TITLE	PARTIAL MEZZANINE/LOW ROOF FRAMING PLAN - AREA B (SEQ-1)		
MADE BY	DATE	CONTRACTOR	JOB No.
PDS	11/30/2020		20028
CHKD BY	DATE	ARCHITECT	ENGINEER
JSY	11/30/2020		
			SHEET NO.
			1E1
			REV.
			A

**PARTIAL MEZZANINE/LOW ROOF FRAMING PLAN @ AREA-B (SEQ-1)**  
 (REF: S2.2 & 1/A1.3)  
 [TOP OF STEEL ELEVATION 114'-0 1/2" U.N.O.]

**PARTIAL LOW ROOF FRAMING PLAN @ AREA-B(SEQ-1)**  
(REF: S2.2 & 1/A1.3)

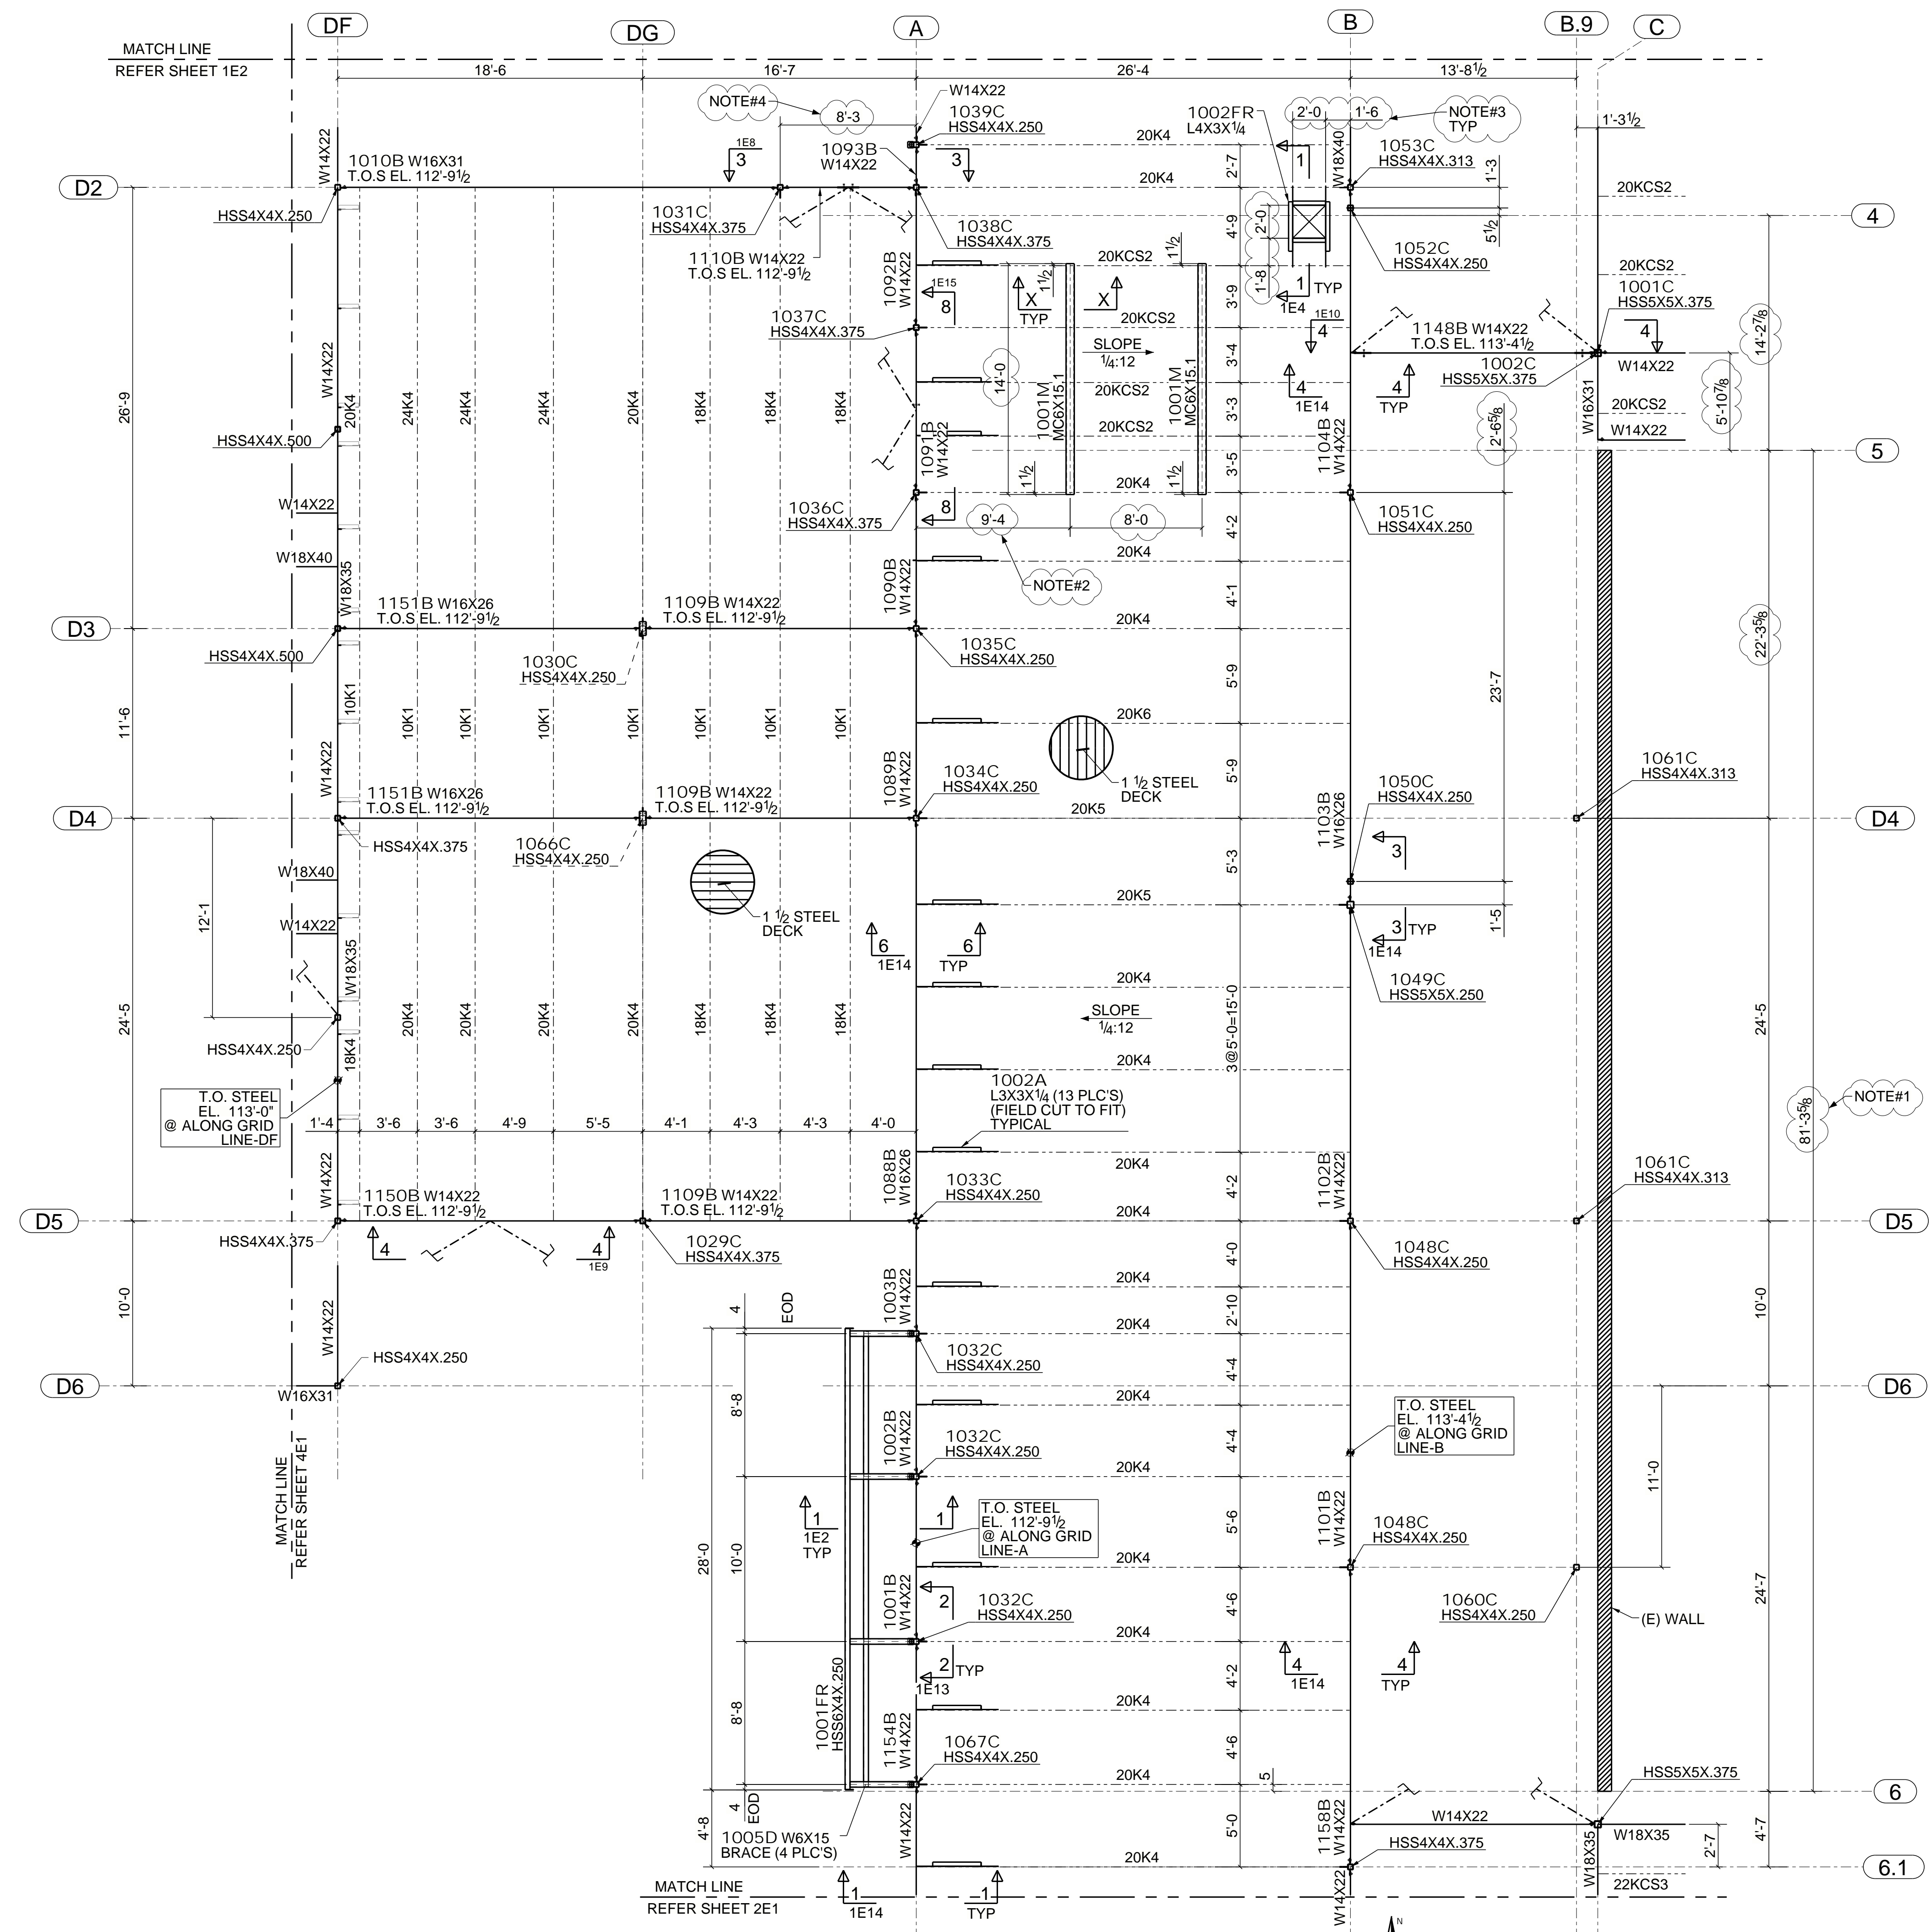
- NOTE#1:- THERE IS CONFLICT IN GRID TO GRID DIMENSION B/W ARCH & STRU DRAWINGS. STRU DRAWING S1.2 SHOWS THIS DIMENSION 81'-4" WHILE ARCH DRAWING AD1.3 SHOWS THIS DIMENSION 81'-3 5/8". CURRENTLY WE HAVE FOLLOWED ARCH DRAWING. PLEASE REVIEW/CONFIRM.
- NOTE#2:- PLEASE VERIFY/CO-ORDINATE THE MECHANICAL UNIT SUPPORT CHANNEL LENGTH/FIXING DIMENSION WITH MECHANICAL UNIT SUPPLIER.
- NOTE#3:- PLEASE VERIFY/CO-ORDINATE THE RTU FRAME FIXING/OPENING DIMENSION WITH MECHANICAL UNIT SUPPLIER.
- NOTE#4:- THERE IS CONFLICT IN COLUMN LOCATING DIMENSION. STRU PLANS2.2 SHOWS THIS COLUMN IS LOCATED AT 8'-3" FROM GRID LINE-A. BUT BRACE DETAIL 3/S4.2 SHOWS THIS COLUMN IS LOCATED AT 8'-3 1/2". CURRENTLY WE HAVE FOLLOWED 8'-3" PER PLAN S2.2. PLEASE VERIFY/SUGGEST.

**PARTIAL HIGH ROOF FRAMING PLAN @ AREA B(SEQ.1)**  
 (REF: S3.2 & 1/A4.1)

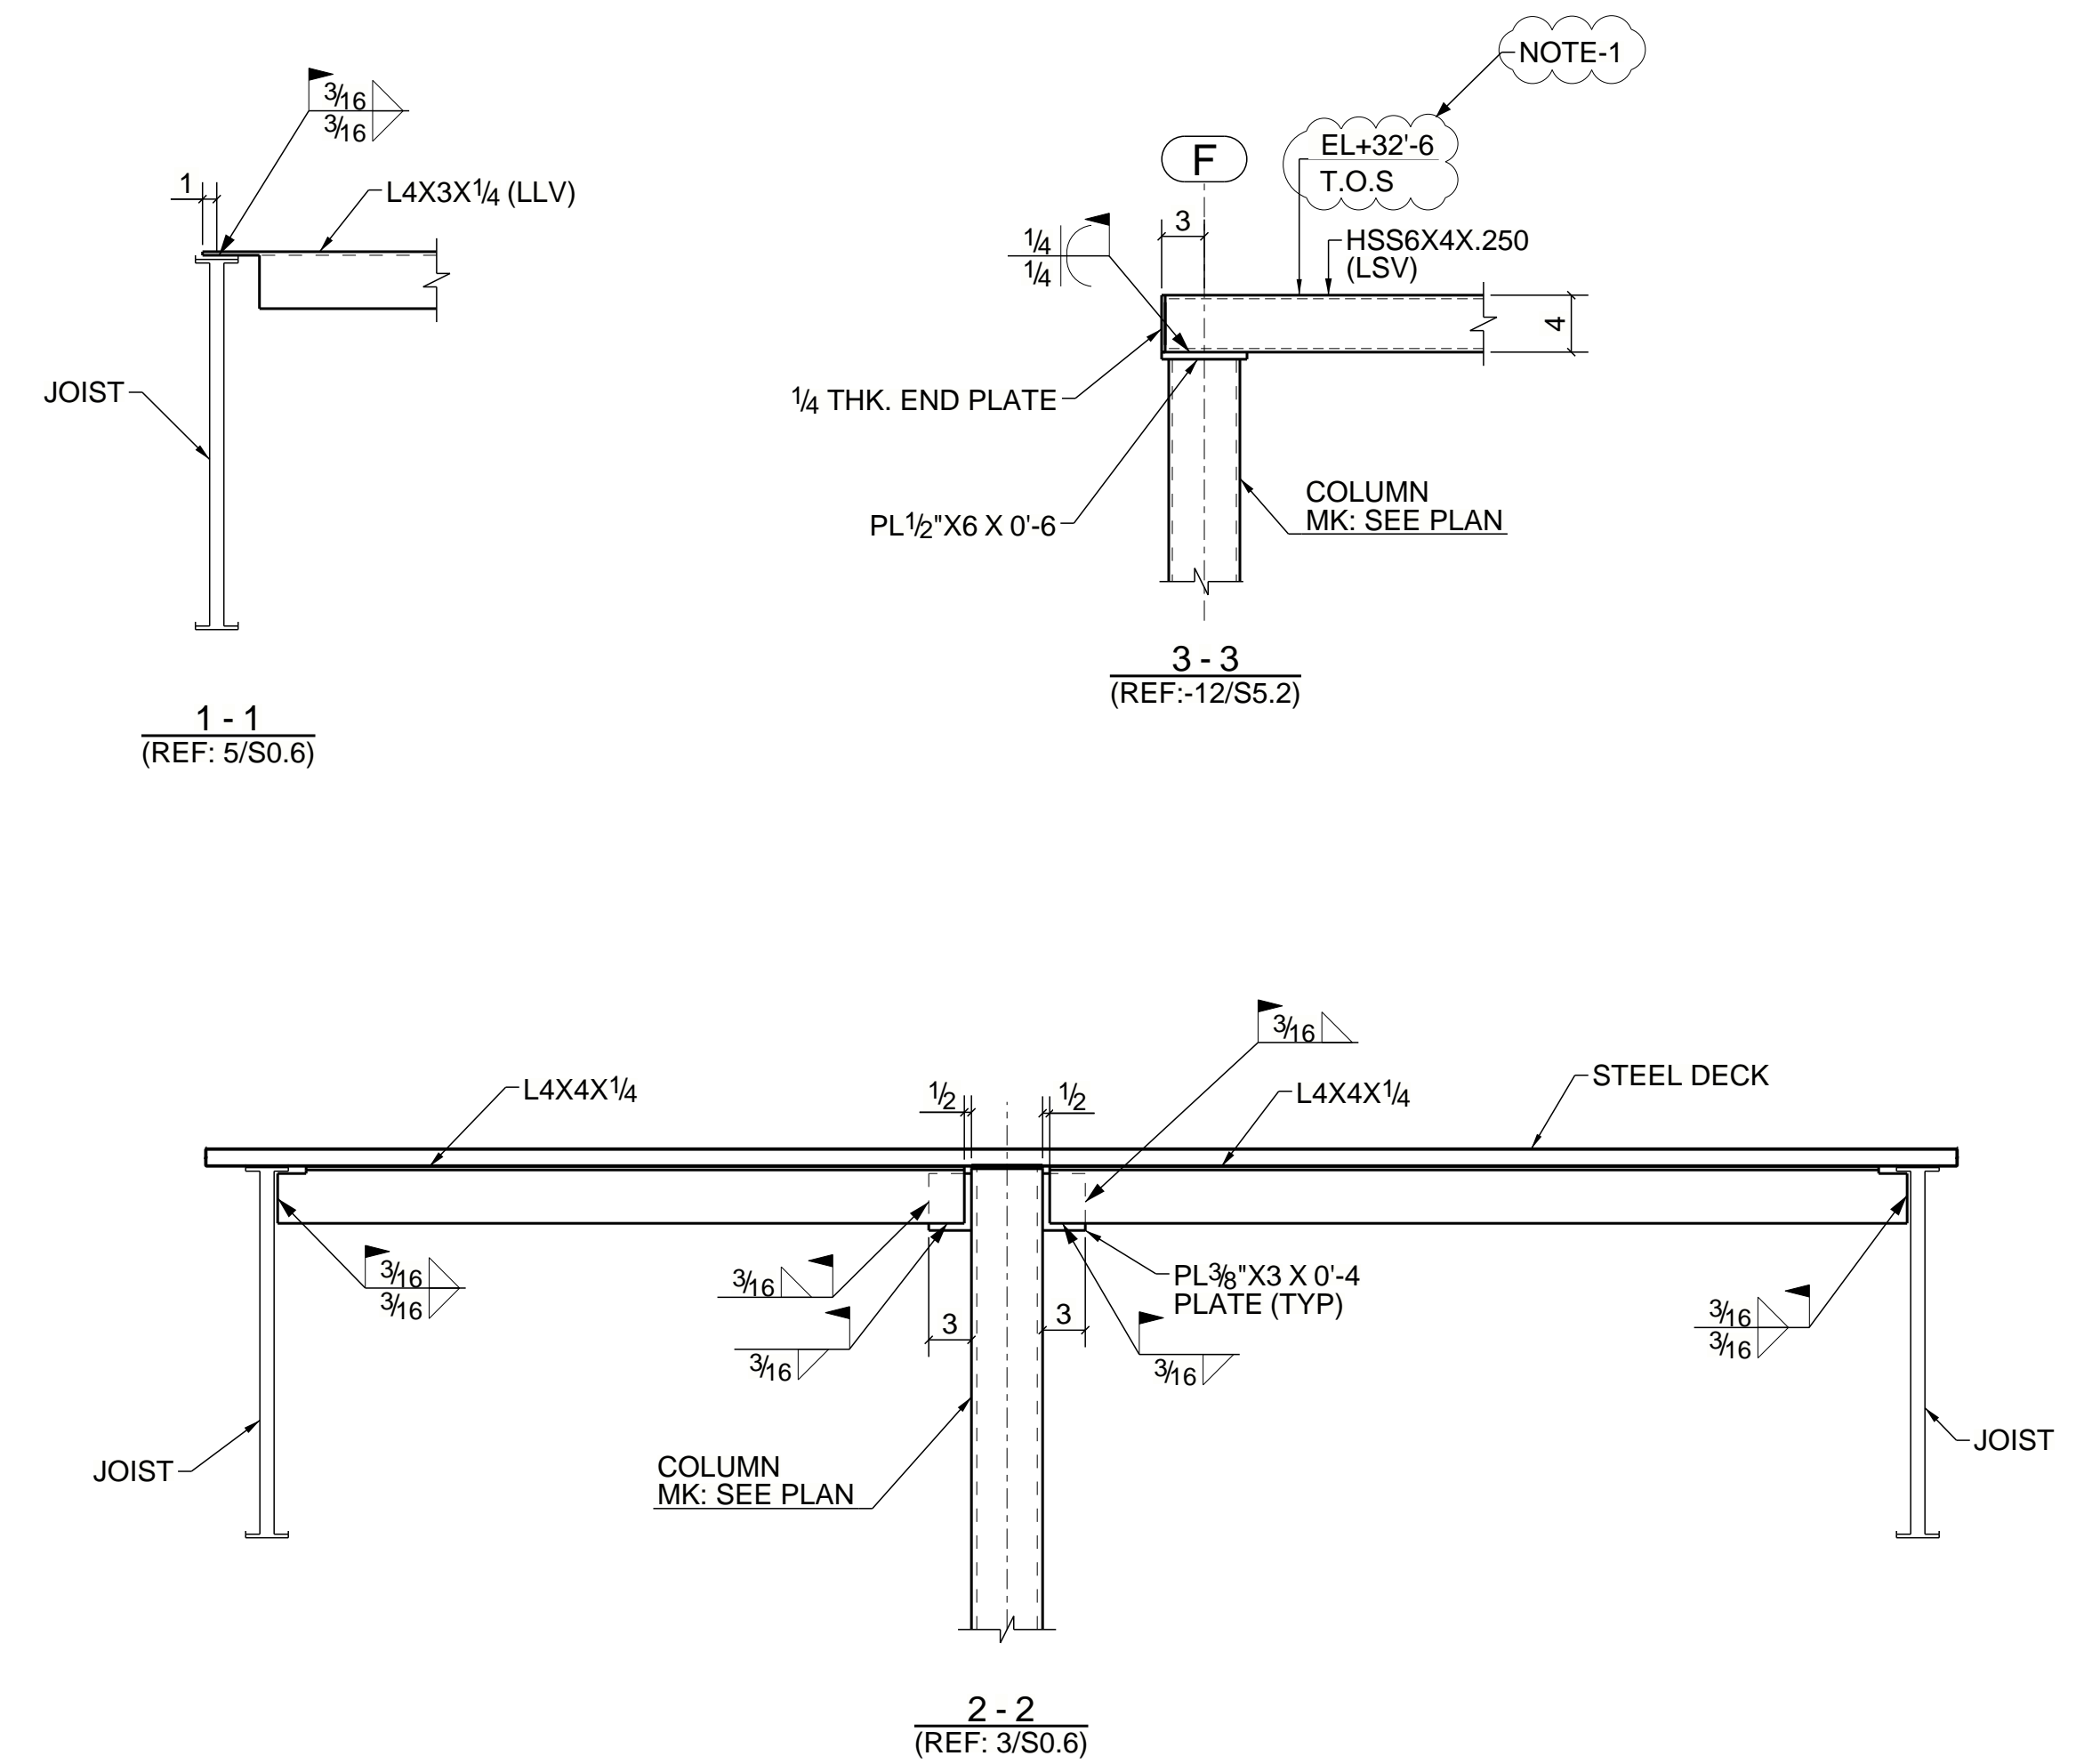
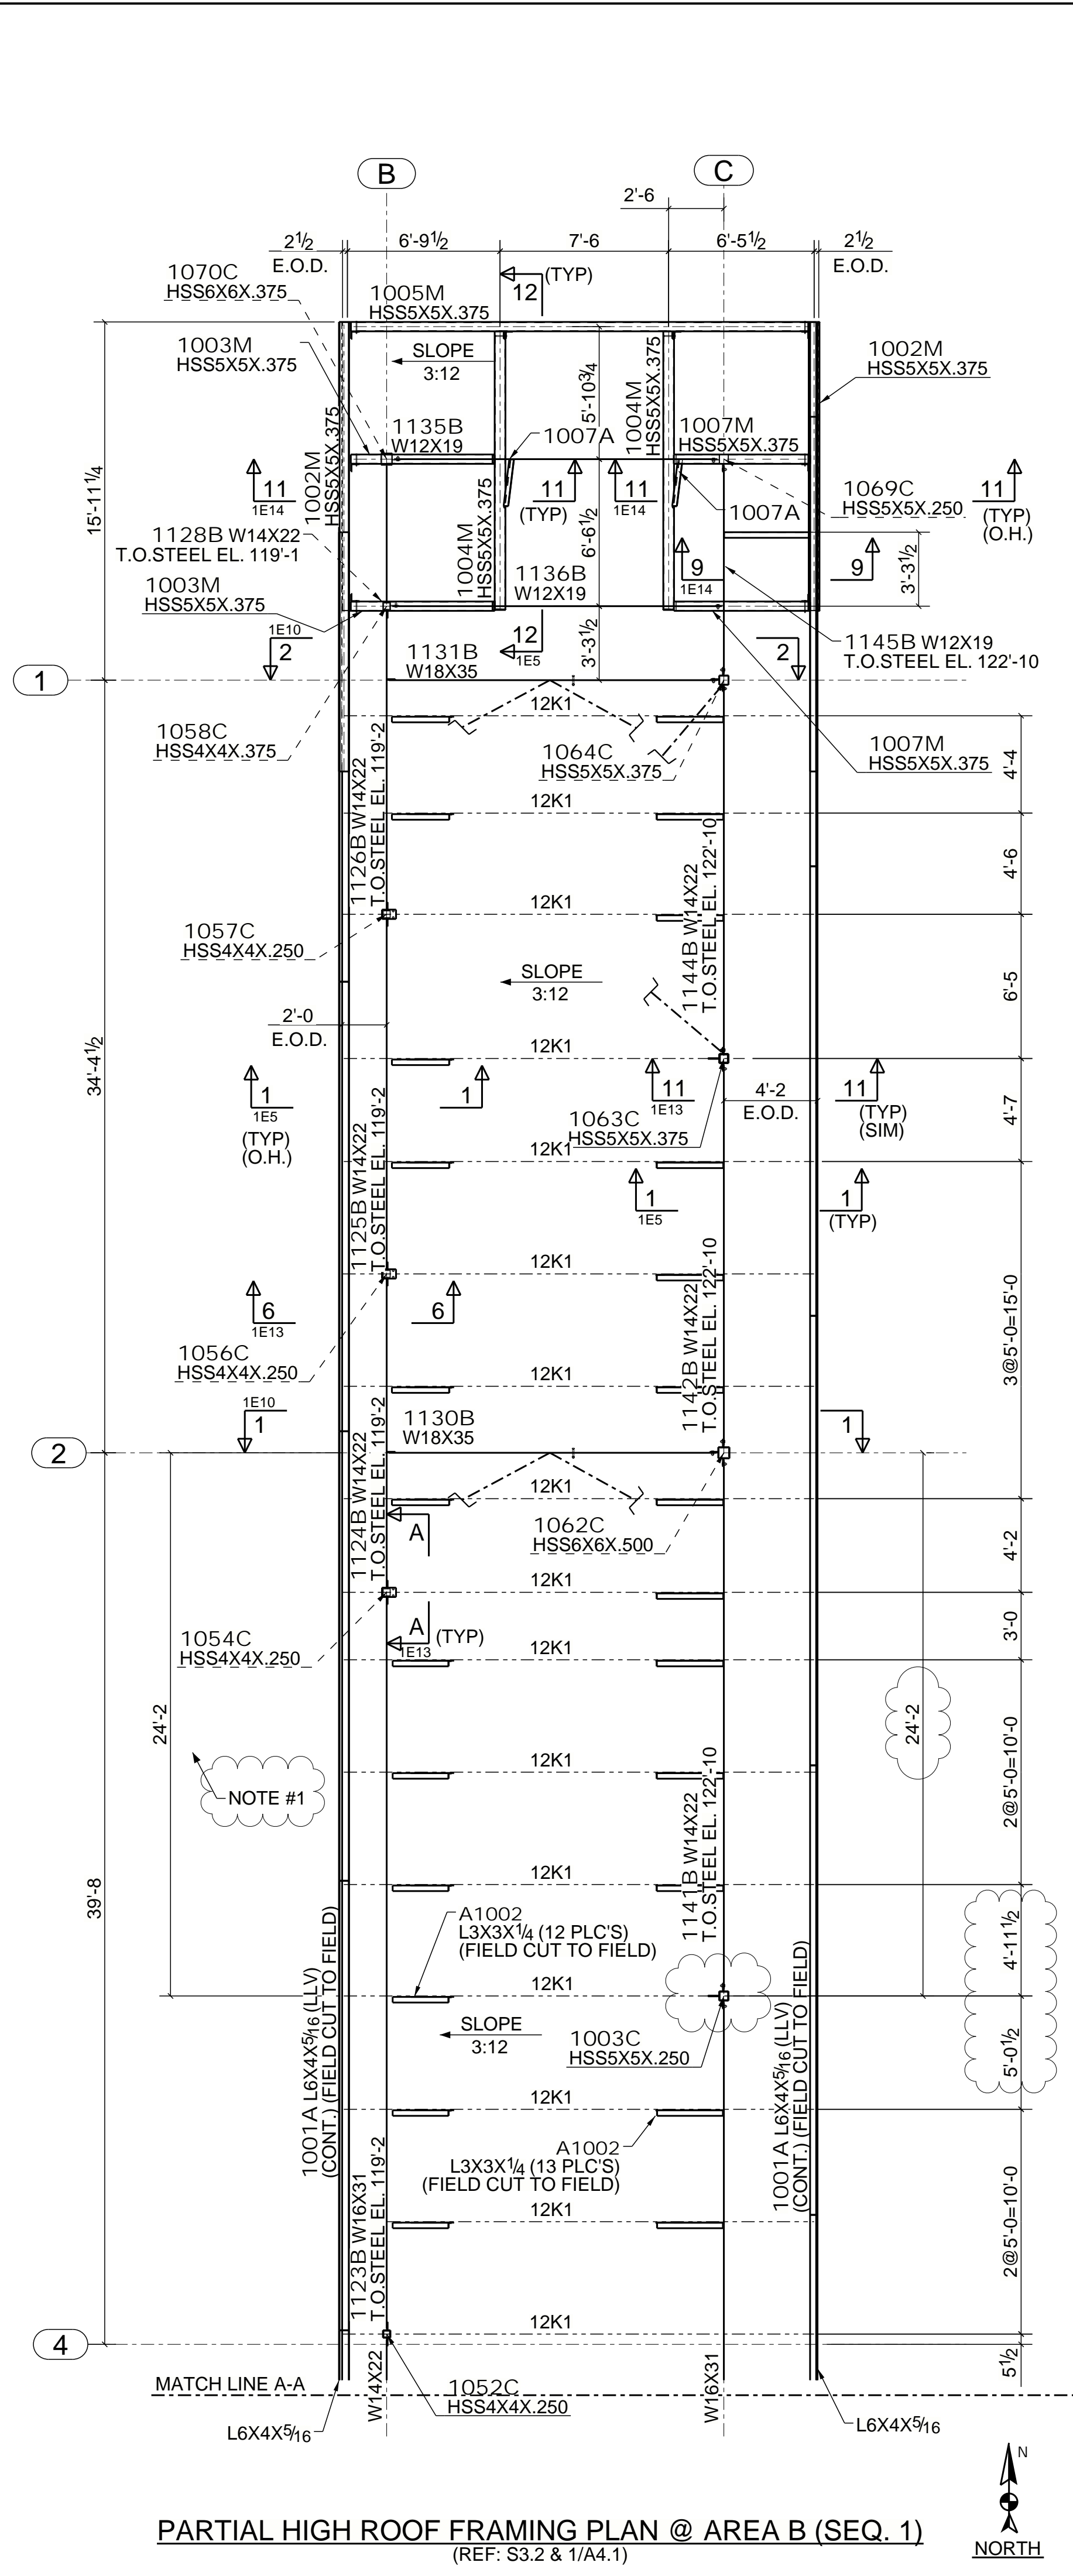
NOTE#1:- PLEASE VERIFY/PROVIDE TOP OF HSS GRIT/TOP OF PARAPET ELEVATION.

NOTE#2:- PLEASE VERIFY/CO-ORDINATE THE LOCATING DIMENSIONS OF THE RTU FRAME ALONG WITH OPENING SIZE WITH MECHANICAL UNIT SUPPLIER.
